21G-15-0146
GOV-01-55-04
ACF-15-0211

Subject: Revision to Chapter 1, General Information, of License SNM-124

Attachments: SNM-124, Chapter Index, dated July 27, 2015
SNM-124, Chapter 1, Revision 4, dated July 27, 2015

Chapter 1, General Information, Revision 4

Figure 1A-1
NFS Corporate Structure

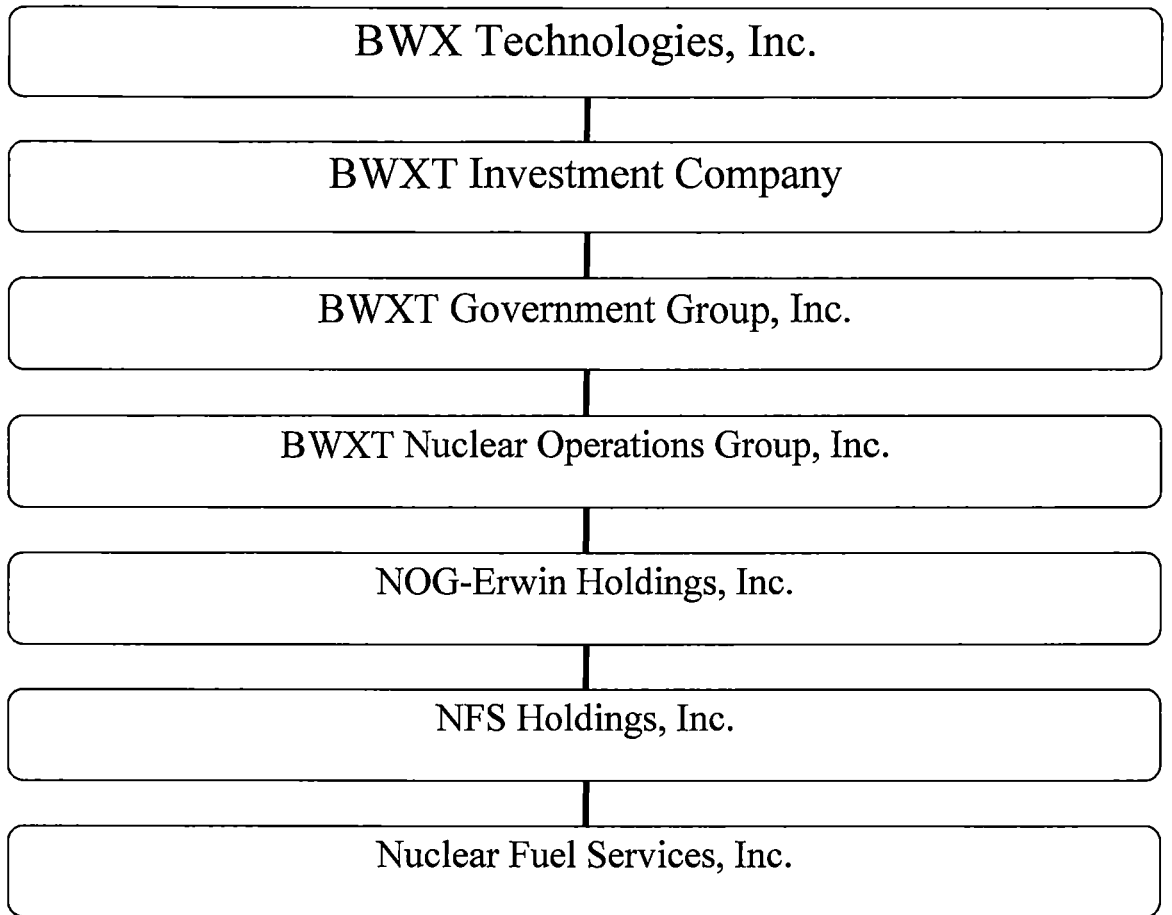
The Babcock & Wilcox Company spin-off of certain non-nuclear affiliates, discussed with the NRC in late 2014, was completed on July 1, 2015. In Reference 5, the NRC stated that the planned B&W corporate actions did not constitute a direct or indirect transfer of control of any NRC license within the B&W chain of companies. As a result of this recent spin-off, NFS has revised the affected pages in Chapter 1 and is submitting them per the requirements of LC S-2.

Tennessee 37650-9718. NFS is a subsidiary of NFS Holdings, Inc., which is a subsidiary of NOG-Erwin Holdings, Inc., which is a wholly-owned subsidiary of BWXT Nuclear Operations Group, Inc., incorporated in Delaware. A summary listing of NFS affiliates is provided in Appendix 1A, along with a figure (Figure 1A-1) showing the reporting relationships.

1. **BWX Technologies, Inc.** is a corporation that owns 100% of the stock of BWXT Investment Company.
2. **BWXT Investment Company** is a corporation that owns 100% of the stock of BWXT Government Group, Inc.

3. **BWXT Government Group, Inc.**, is a corporation that owns 100% of the stock of BWXT Nuclear Operations Group, Inc.
4. **BWXT Nuclear Operations Group, Inc.**, is a corporation that owns 100% of the stock of NOG-Erwin Holdings, Inc.

5. **NOG-Erwin Holdings, Inc.**, is a corporation which owns 100% of the stock of NFS Holdings, Inc.
6. **NFS Holdings, Inc.**, is a corporation which owns 100% of the stock of Nuclear Fuel Services, Inc.
